Legislative Department
Seattle City Council
Memorandum

Subject: March 23, 2011, COBE Meeting: South Downtown Zoning Proposal

Council Bill (C.B.) 117073 would amend the Land Use Code to revise zoning regulations in South Downtown. This memo continues the discussion started at previous meetings of the Committee on the Built Environment (COBE).

1. 16th and Lane Rezone

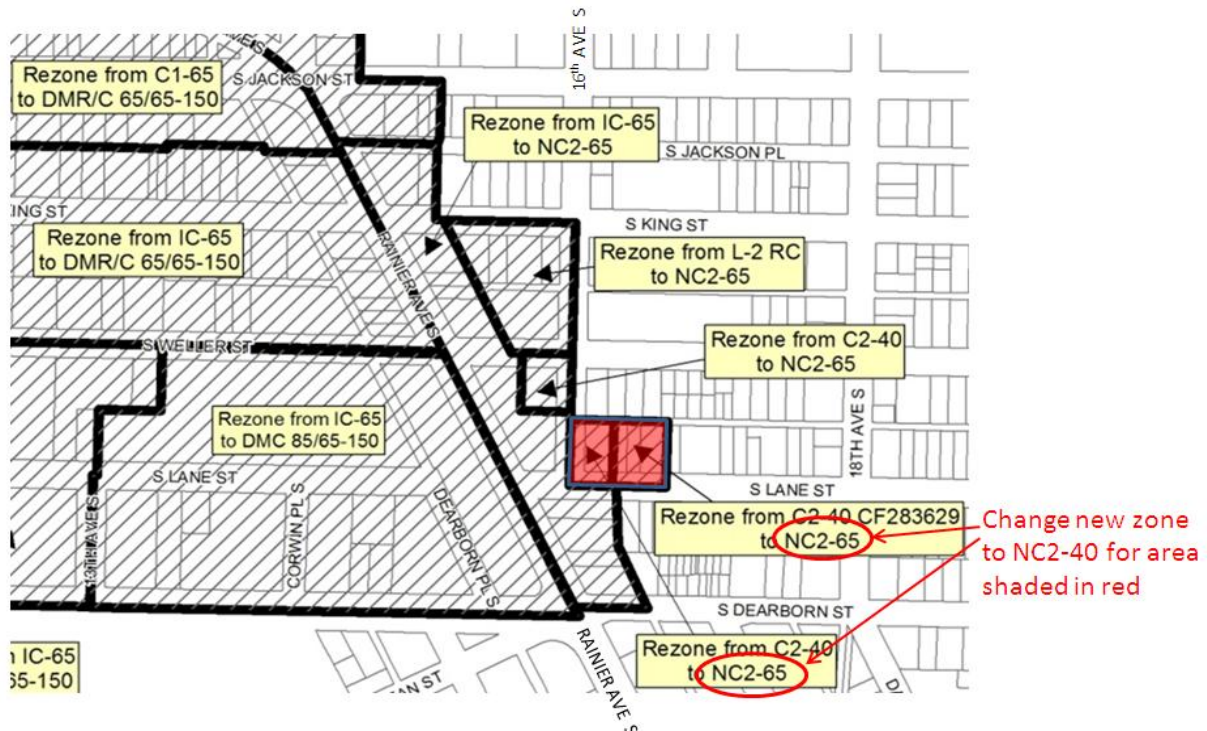
Amend Exhibit B to C.B. 117073 so the new zone for the parcels at the northeast corner of 16th Avenue S. and S. Lane Street will be NC2-40 (instead of NC2-65), as shown below.

Proposed amendments would result in the following places where requirements would apply.

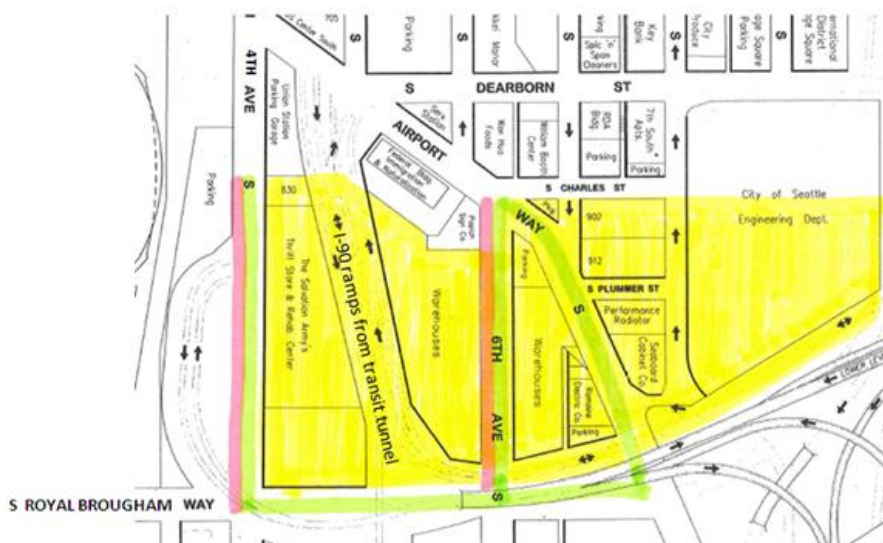
The particular amendments shown below arose from more detailed staff-level discussions about what makes the most sense for the specific streets in the area south of S. Charles Street. The amendments would ease the requirements that govern façades and street-level uses in the area as follows:

- Delete the requirement for street-level uses on S. Charles Street;
- Reduce the required minimum façade height from 50 feet to 25 feet for facades facing 4th Avenue S., 6th Avenue S., Airport Way S., and S. Royal Brougham Way;
- Reduce the required minimum façade height from 25 feet to 15 feet for facades facing other streets;
- Delete the requirement for a principal pedestrian entrance on S. Charles Street; and
- Reduce the façade transparency requirement on S. Charles Street from 60 percent to 40 percent of the street-facing façade.

The requirements that would result after approval of the amendments can be summarized and depicted as follows:
